STAFF'S
REQUEST ANALYSIS
AND
RECOMMENDATION

07TS0408

DLM, LLC
(Watermark Phase II)

REQUEST: DLM, LLC is requesting tentative subdivision approval for 217 single family lots. In addition, the applicant is seeking approval of the alignment of the east/west major arterial as shown on the proposed tentative.

WATERMARK PH2

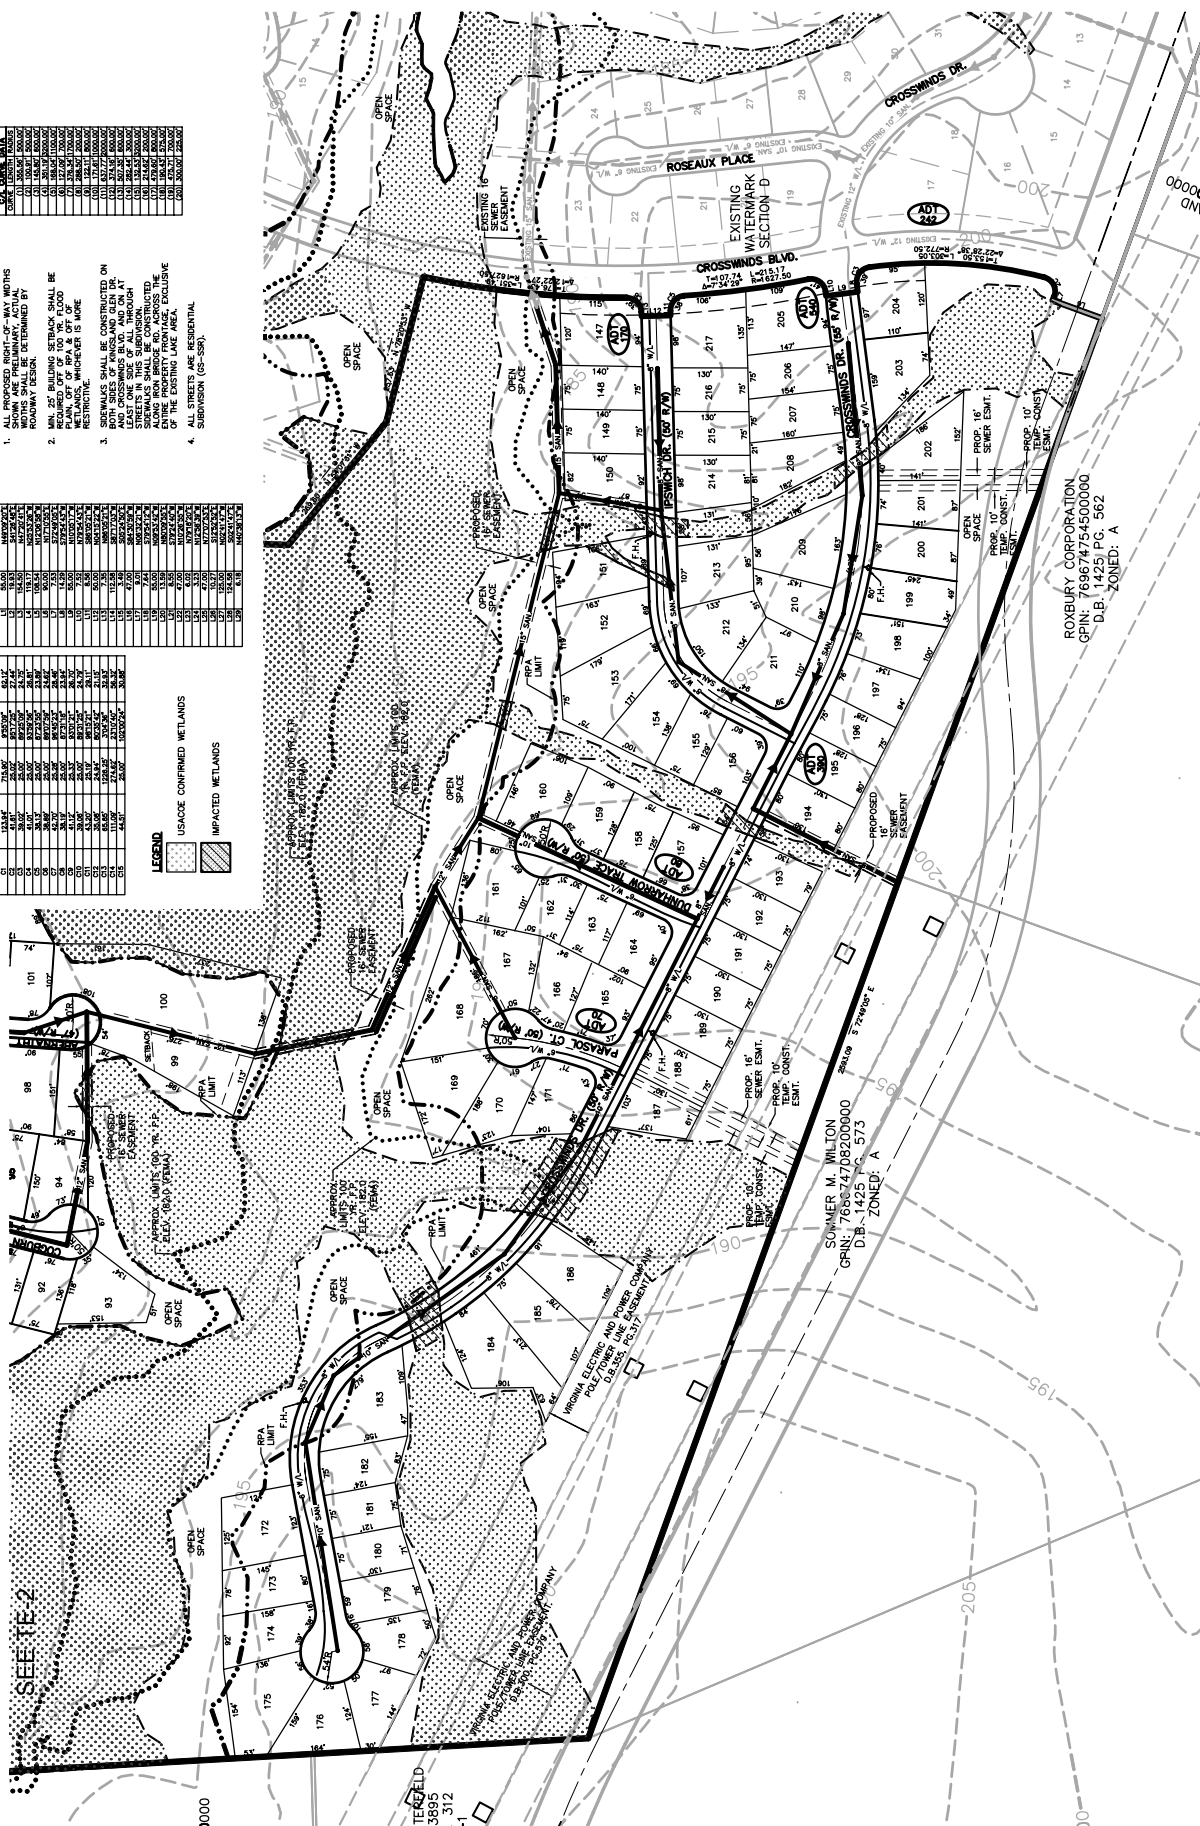
- A. Hydrant requirements and locations shown on the tentative plan may not be acceptable. Hydrant(s) required and their location will be evaluated at the time of construction plan review. (F)
- B. When submitting the construction plans, provide an additional copy to go to the Fire Department for review. (F)
- C. Compliance with 17-76 of the Subdivision Ordinance in the Chesterfield County Code shall be maintained. (F)
- D. In conjunction with the submittal of the final check plat, flag all buffers and contact the Planning Department to schedule an inspection of the same. Buffers must comply with section 17-70 of the Subdivision Ordinance. (P)
- E. A fifty (50) foot buffer exclusive of required yards and easements is required adjacent to Cogbill Road. (P)
- F. On construction plans insert instructions for installation of tree protection fencing or tape for buffers (P)

- I. The engineer is to design the on-site sewer line for Phase 2 which ties into Phase 1 such that it can serve all adjacent properties located south of the boundary line of Watermark Phase 1 and 2 and are within the limits of the drainage area of the existing trunk sewer line within Watermark Phase 1. (U)

- K. This office may require redesign or modifications to the proposed sewer layout, as shown on the tentative plan, once the field work and final design has been completed by the engineer and shown on initial construction plan submittal for review and approval. (U)

- N. All right of way widths as shown are preliminary and should be so noted. Actual widths shall be determined by roadway design as stipulated in Appendix B of the 2005 Subdivision Street Requirements (SSR). (VDOT)

- W. Only one (1) curb and gutter design may be used along the length of a street, as per 24VAC 30-91-110. (VDOT)
- X. A forty-five (45) foot edge of pavement radius turnaround is required at the cul-de-sac on Whisperwood Drive and Crosswinds Drive, per Appendix B of the 2005 SSR. A minimum fifty-four (54) foot right of way radius is required to accommodate the enlarged turnaround at these locations. (VDOT)

- Y. Sanitary sewer manholes as shown are preliminary and should be so noted. Actual locations of utility manholes shall be shown on construction plans and in accordance with Appendix B of the 2005 Subdivision Street Requirements (SSR). (VDOT)

THOROUGHFARE PLAN
ATTACHMENT 1

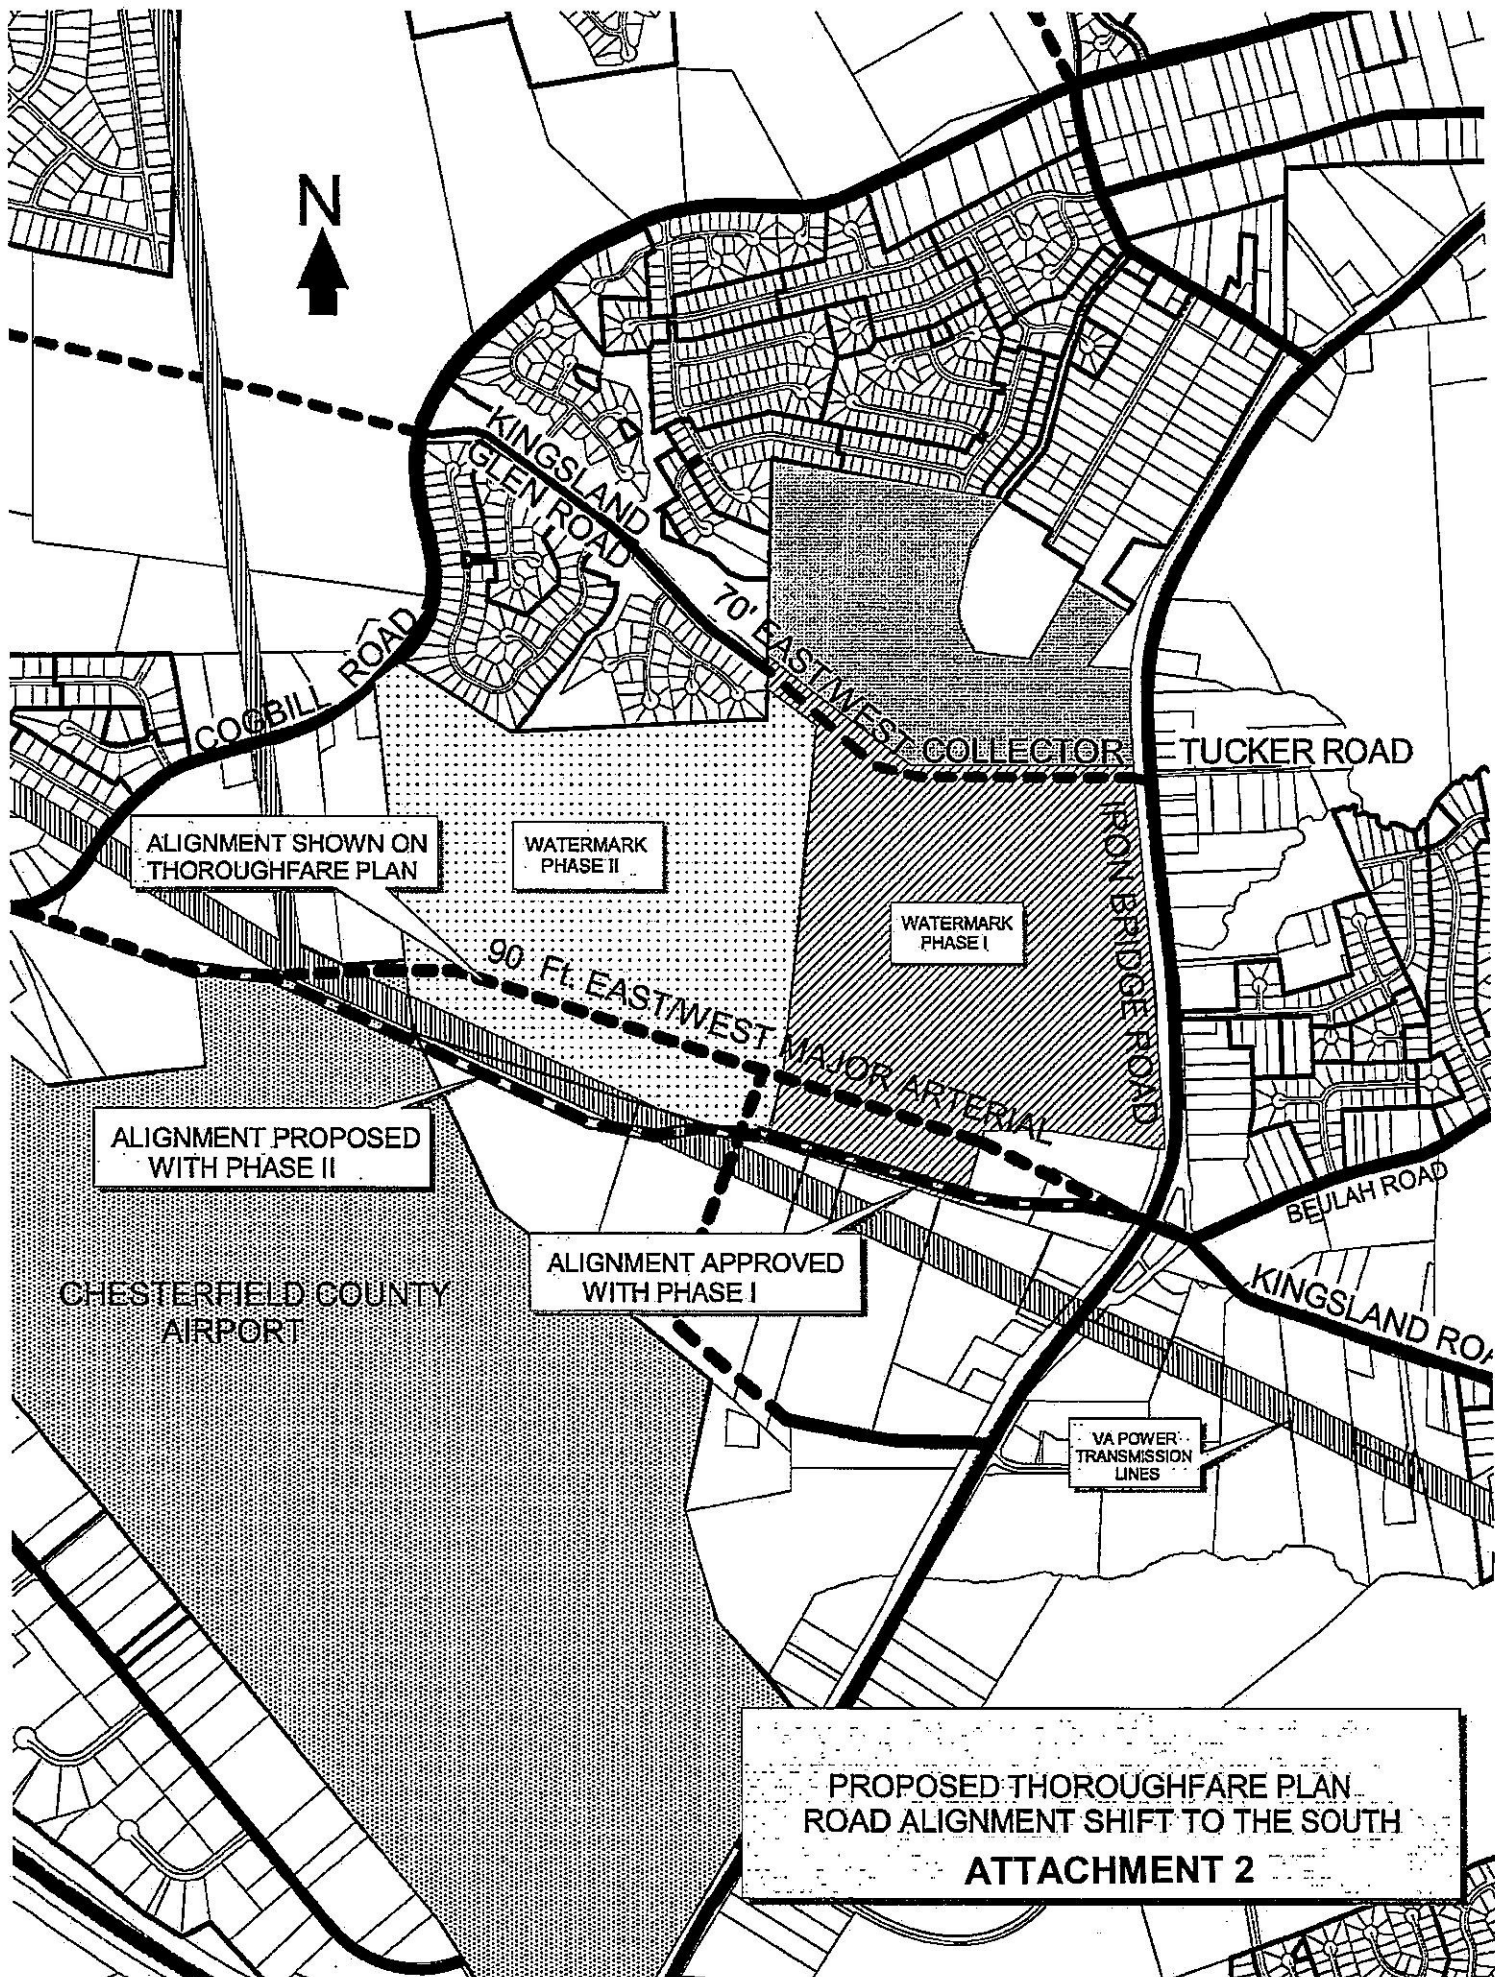
Watermark development lies within Residential R-7 zoned property with no proffered conditions. The development contains two (2) roads identified on the Thoroughfare Plan, an east/west seventy (70) foot collector, and an east/west ninety (90) foot major arterial. (Attachment 1) On December 21, 2006, Watermark Phase I, Case 06TS0212, received administrative tentative approval with conditions for 224 single family residential lots. Watermark Ph I lies adjacent to the eastern boundary of the properties included within this case. The Watermark Phase I case was approved with an additional condition which required dedication of the right of way and construction of an east/west collector road and part of an east/west ninety (90) foot major arterial within the limits of the Phase I tentative. (Attachment 2)
